Berichtigung: RWY-Bezeichnung, Platzrunde, An-/Abflüge, Bemerkung, Missweisung, Topografie.  
Correction: RWY designation, traffic circuit, APCH/DEP routes, remark, variation, topo.

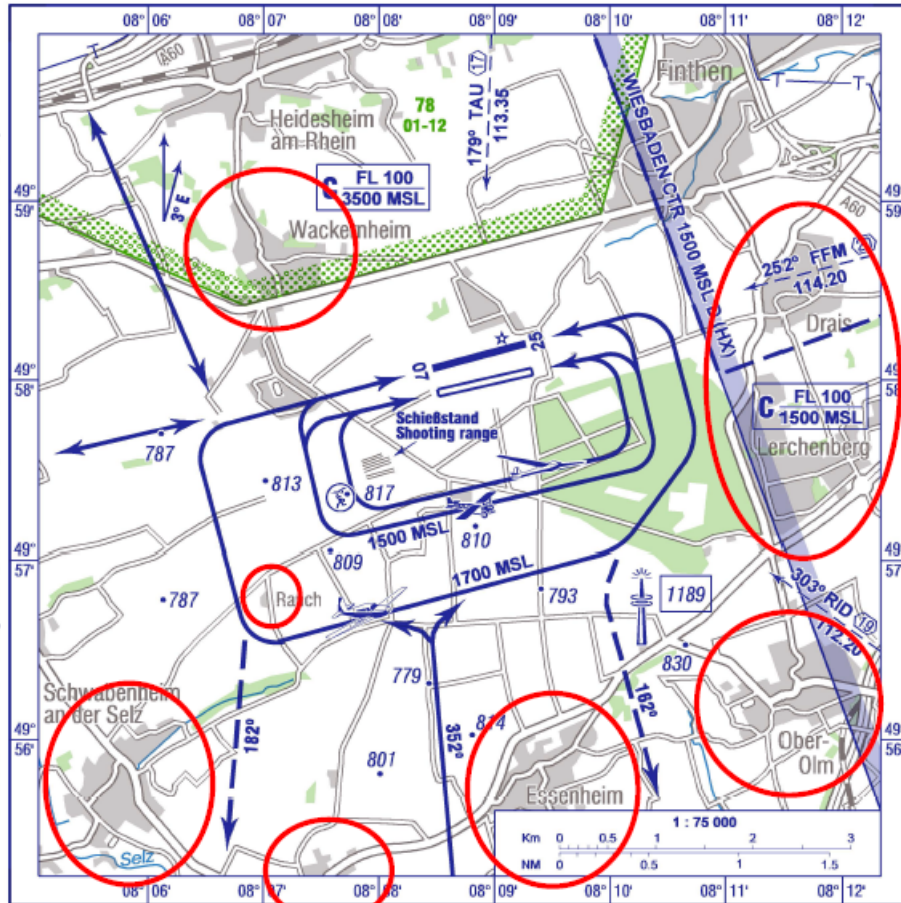
Die umliegenden Orte sowie Raich sind lärmempfindliche Gebiete, Überflüge möglichst vermeiden. Schulungsflüge von Hubschraubern in der Platzrunde sind nicht gestattet. Überflüge des Schießplatzes im westlichen Teil der Segelflugplatzrunde sind zu vermeiden. Direktanflüge RWY 07 sowie Direktabflüge RWY 25 sind im Einzelfall zulässig, wenn MAINZ INFO zugestimmt hat und der Platzrundenverkehr dem nicht entgegensteht.

The surrounding villages and ranch are noise-sensitive areas, overflights shall be avoided, if possible. Helicopter training flights in traffic circuit are not permitted. Overflights of the shooting range in the western part of the traffic circuit for gliders shall be avoided. Direct approaches to RWY 07 and direct departures from RWY 25 are permitted after prior approval from MAINZ INFO provided that circling traffic is not compromised.
